30 October 2025

Chief Executive Officer
Northern Beaches Council

**31 Cook Terrace Mona Vale
Modification under Section 4.55(2) to Development Consent DA2025/0750 to
alter the approved development**

Figure 2 - ground floor plan - proposed modification showing the planter accommodated within the approved living room space and 6,480mm to the front boundary

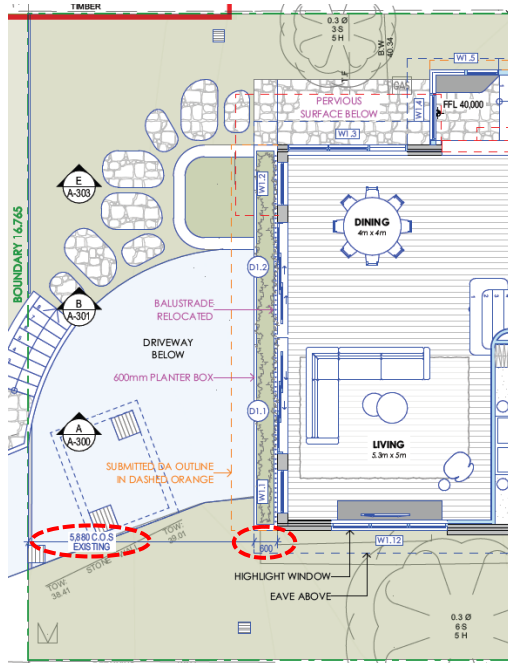
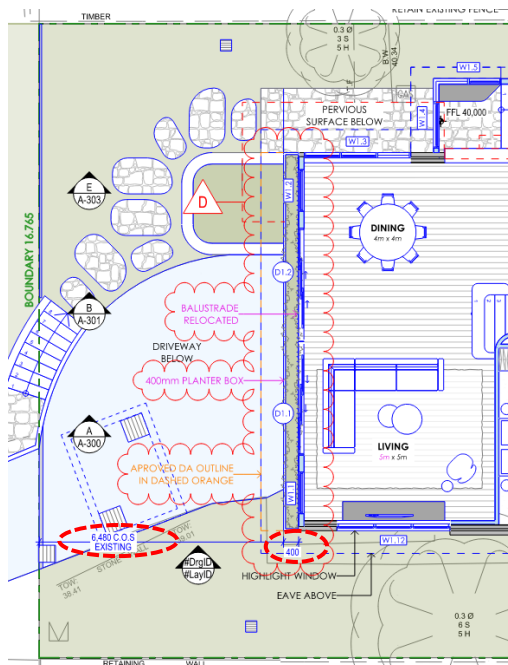
The original plans included a planter [600mm deep] generally in this location, however during the development assessment, concerns were raised due to the location of the planter and its potential to impact on existing sightlines from the neighbouring property at 29 Cook Terrace. As a result, condition 11 was imposed in the consent to remove the planter.

The modified design addresses the sightline concern by reducing the depth of the planter [to 400mm], maintaining the existing front setback, and accommodating the planter within front setback of the approved living room space. As a result, the proposed ground floor front setbacks are:

- 6,480mm to the planter box along the front façade.
- 6,880mm to the ground floor living room front façade.

Figure 1 - ground floor plan - approved [subject to condition 11]
